Access Compliance Report Public Rights-of-Way (Curb Ramps)

Main Street: ST_VINCENT_PL		Cross Street: BIMINI_DR		Location:	S
ADA ID: RPRK211013144310	Ramp Type: Type 6 - Directional 1	Initial Pass/Fail: Pass	Overall Compliance: No	Severity Score:	14
Codes/Mitigation Info/Possible Solution			Field Measurements/Component Compliance

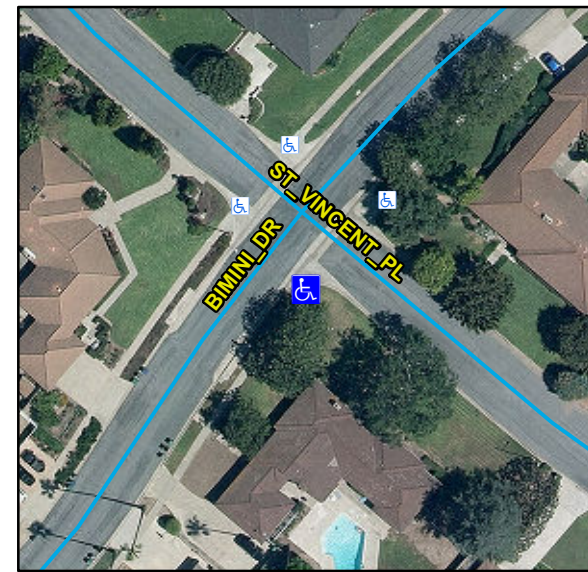
R304.2.1, R305, STD 1115

Remove & Replace Entire Ramp.
